### Chipita Park Road (60 feet)

The applicant requests approval from the Board of Adjustment for a dimensional variance to:

1. Legalize a front setback of 1 foot for a carport where 25 feet is required,
2. Legalize a front setback of 20 feet where 25 feet is required for a single-family detached dwelling,
3. Legalize a lot size of 0.75 acres (32,670 square feet), where 5 acres is the minimum lot size within the R-T (Residential Topographic) zoning district.

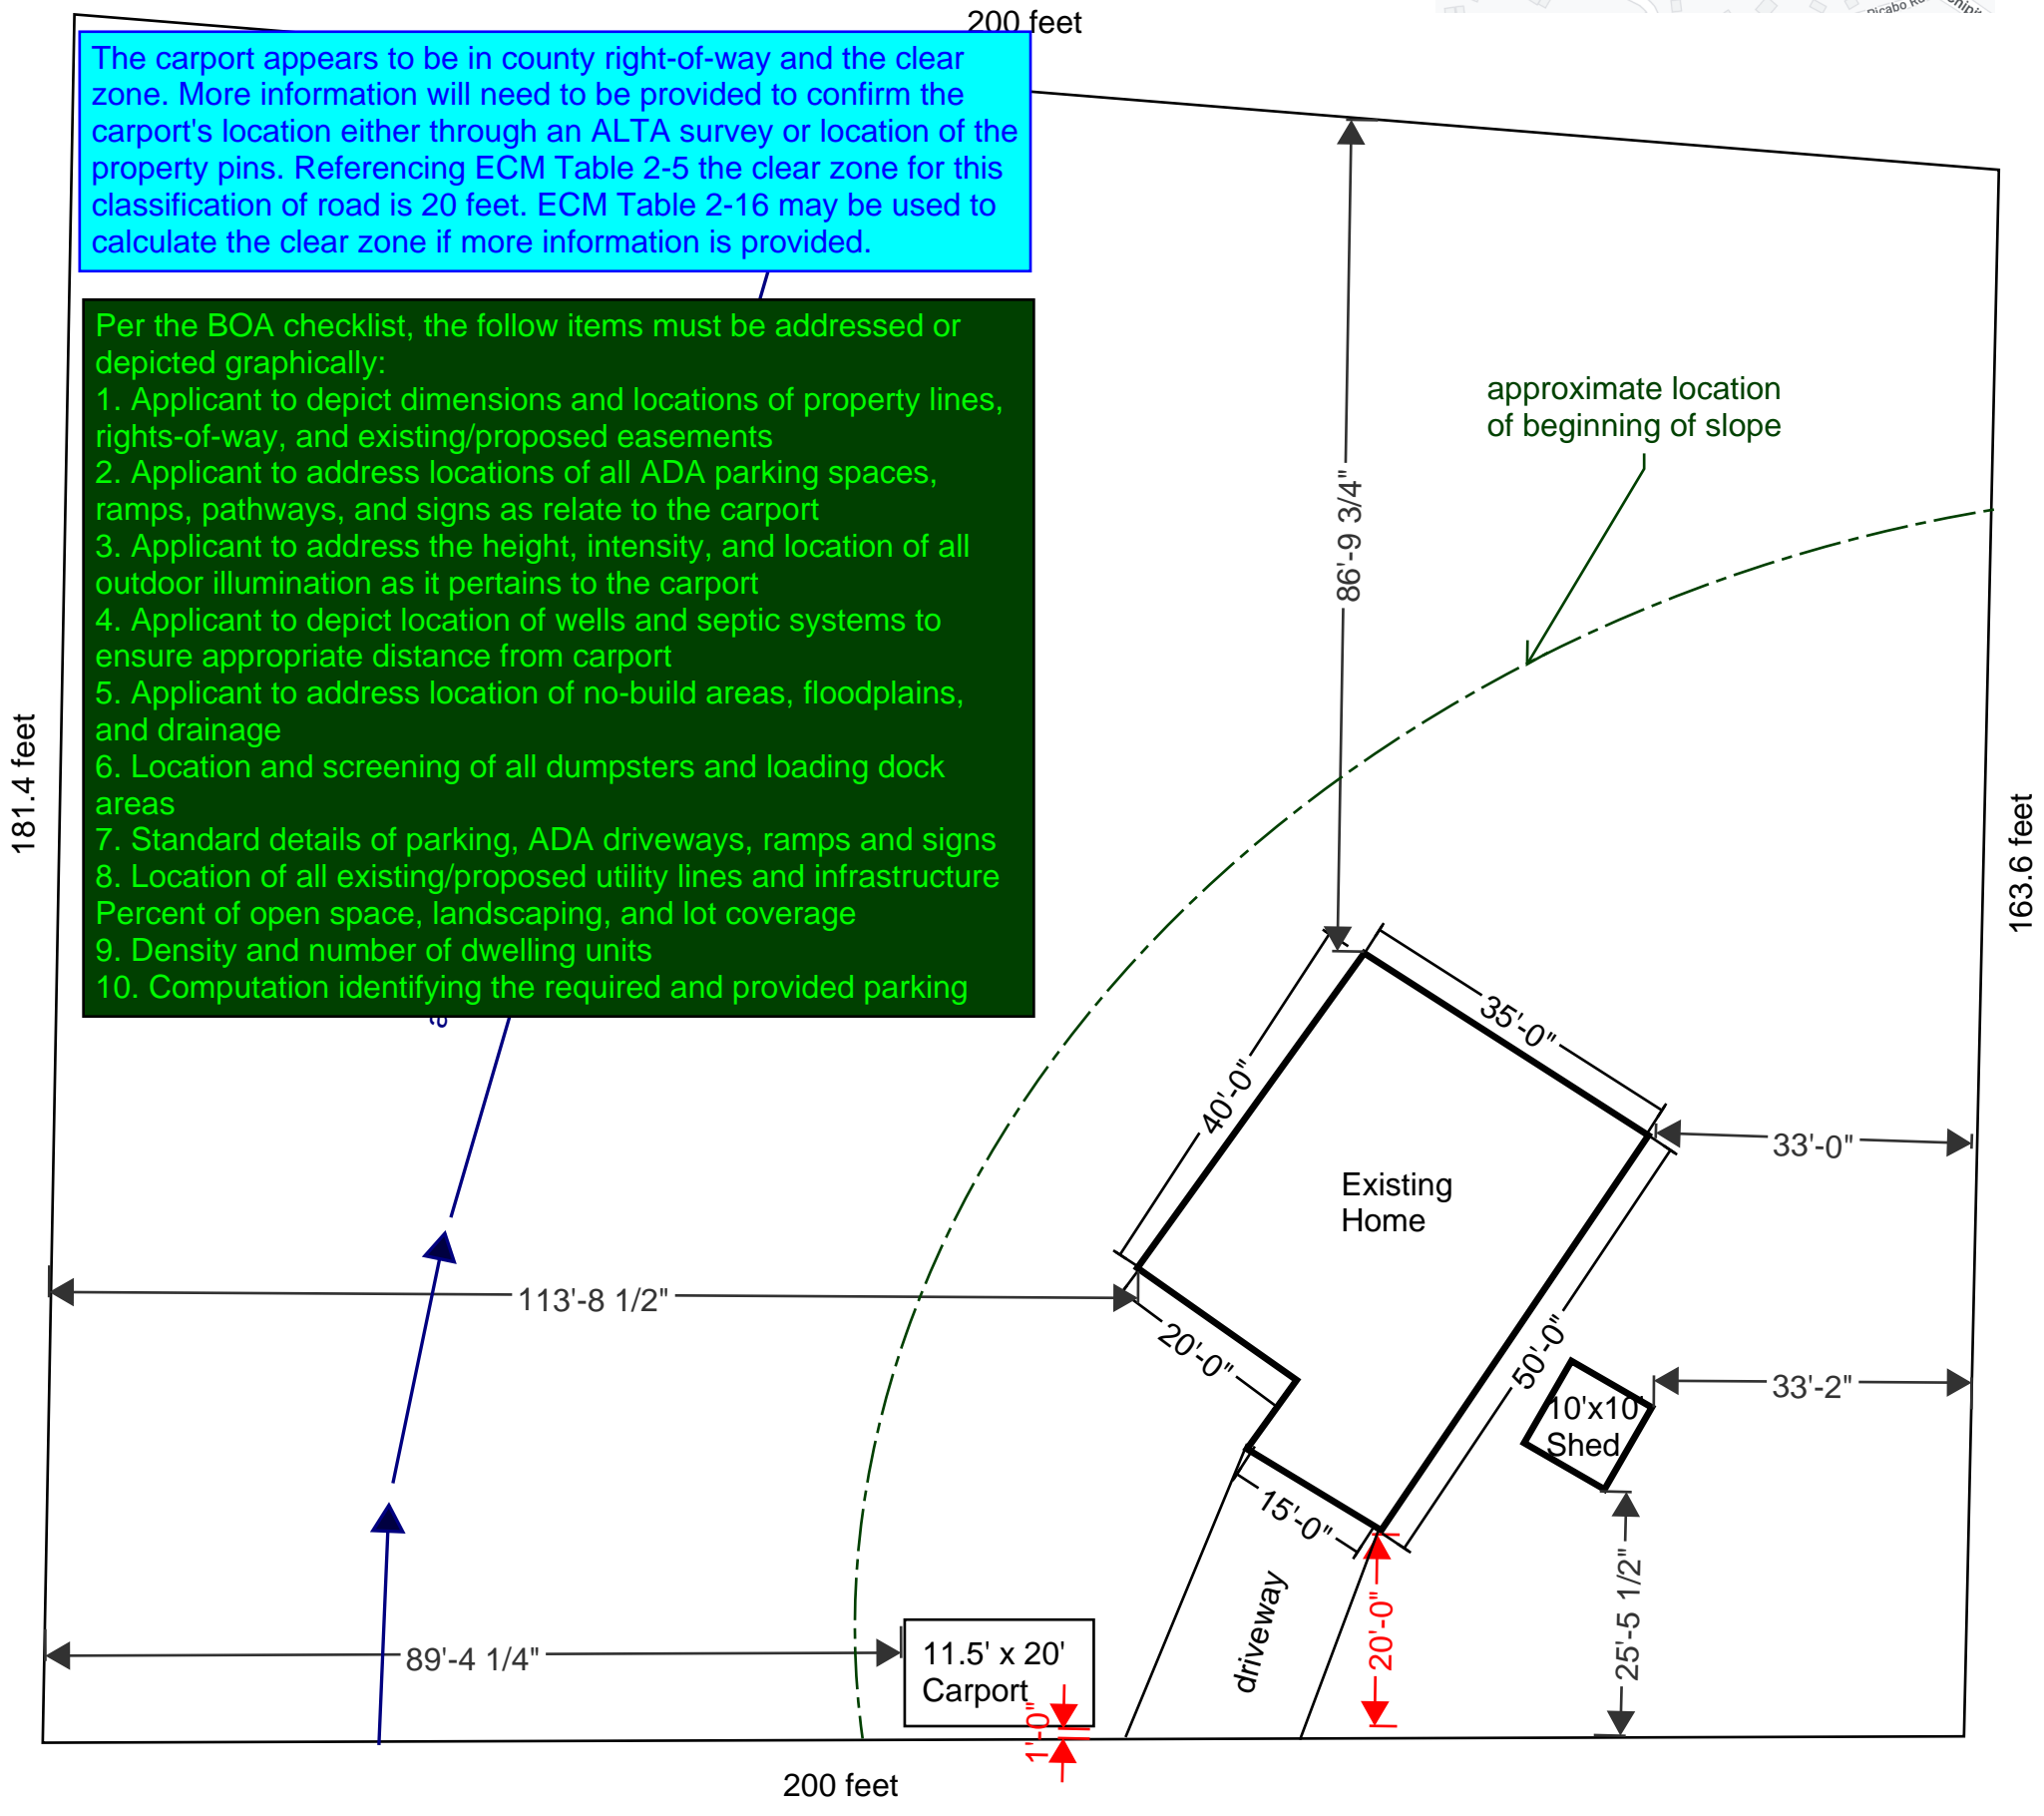
The carport appears to be in county right-of-way and the clear zone. More information will need to be provided to confirm the carport's location either through an ALTA survey or location of the property pins. Referencing ECM Table 2-5 the clear zone for this classification of road is 20 feet. ECM Table 2-16 may be used to calculate the clear zone if more information is provided.

- Per the BOA checklist, the follow items must be addressed or depicted graphically:
1. Applicant to depict dimensions and locations of property lines, rights-of-way, and existing/proposed easements

2. Applicant to address locations of all ADA parking spaces, ramps, pathways, and signs as relate to the carport
  3. Applicant to address the height, intensity, and location of all outdoor illumination as it pertains to the carport

4. Applicant to depict location of wells and septic systems to ensure appropriate distance from carport
  5. Applicant to address location of no-build areas, floodplains, and drainage

6. Location and screening of all dumpsters and loading dock areas
  7. Standard details of parking, ADA driveways, ramps and signs
  8. Location of all existing/proposed utility lines and infrastructure

9. Density and number of dwelling units
  10. Computation identifying the required and provided parking
